INSTRUCTION MANUAL ADDENDUM

| PUBLICATION NO.: PM — 0700 | DATE OF ISSUE: 20 September 1968 |
| MODEL: RF-301 | CHANGES EFFECTIVE: 2694-2723 only |

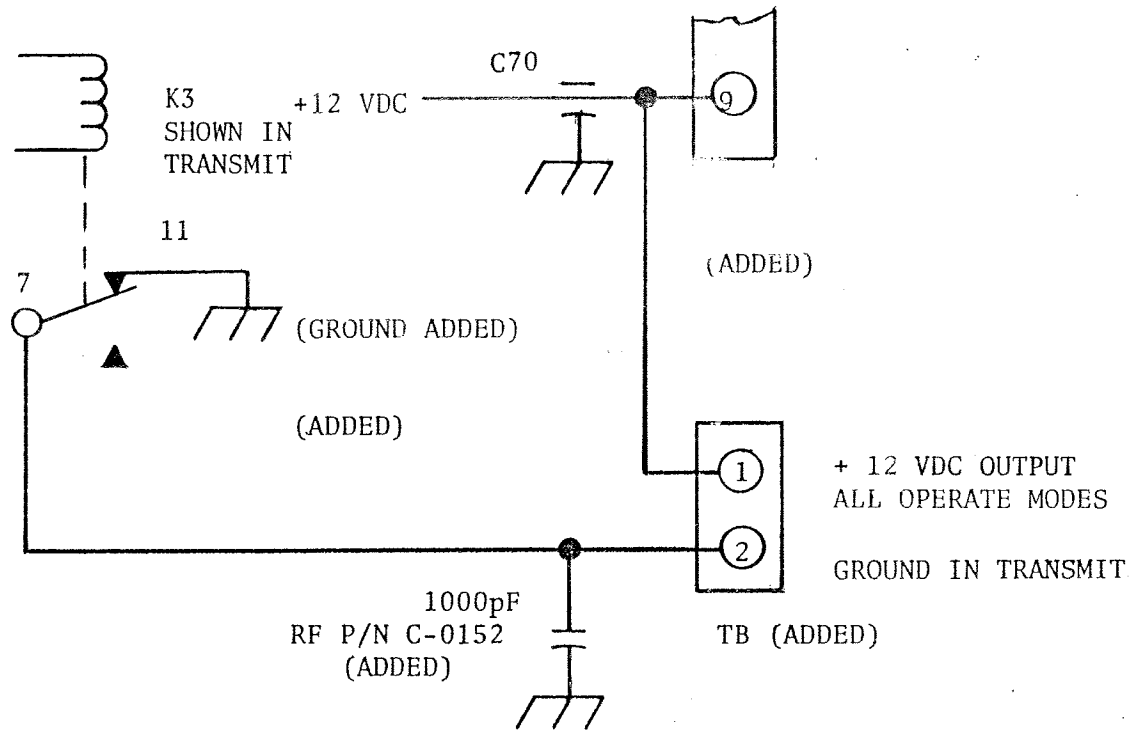
The above listed RF-301 SSB Transceivers have been modified to provide an external keyline output signal (ground in transmit) and a external operate mode (+12 vdc for all operate modes of the RF-301) signal. The modification consists of the addition of a terminal board to the rear panel of the unit, above REMOTE connector J3, an added capacitor, and interconnecting wiring. The diagram below shows the modification schematically.

Pg. 8-9/8-10, Schematic Diagram, 162-0500.....

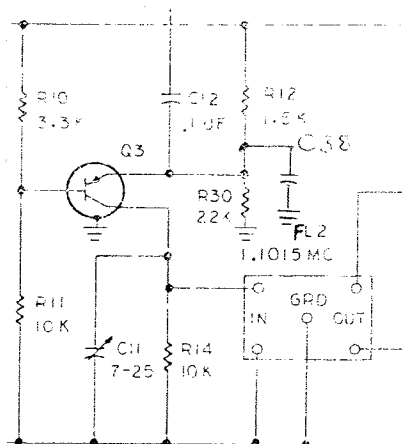
Add: C38 .005uF

Show C38 added at the junction of R12 and R30 as
shown below:

Pg. 8-23/8-24, Schematic Diagram.....

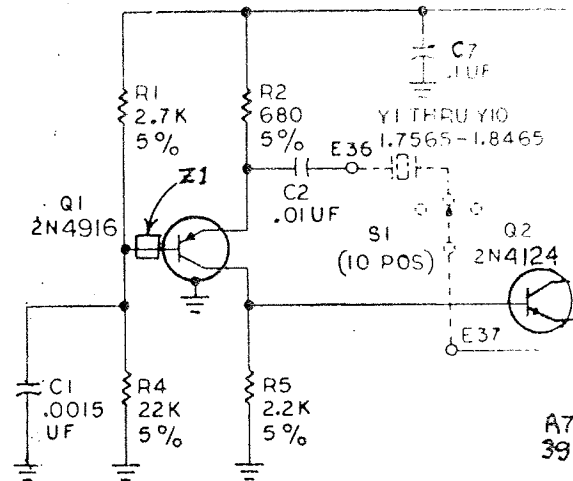
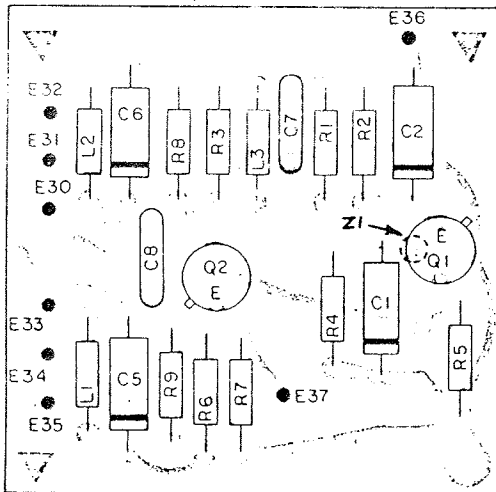
Add: Z1 Ferrite Bead

Show Z1 added to base lead of Q1 as shown
below:

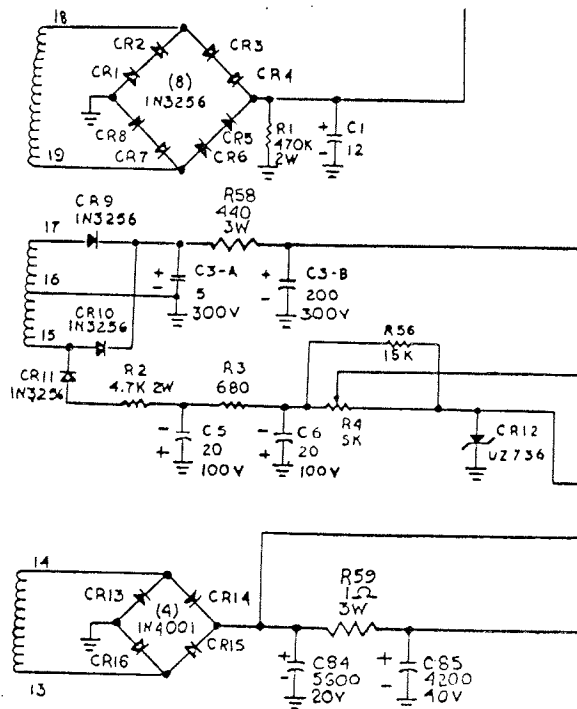
Add: Resistor R59 (1 ohm; 3W) as shown in diagram below:
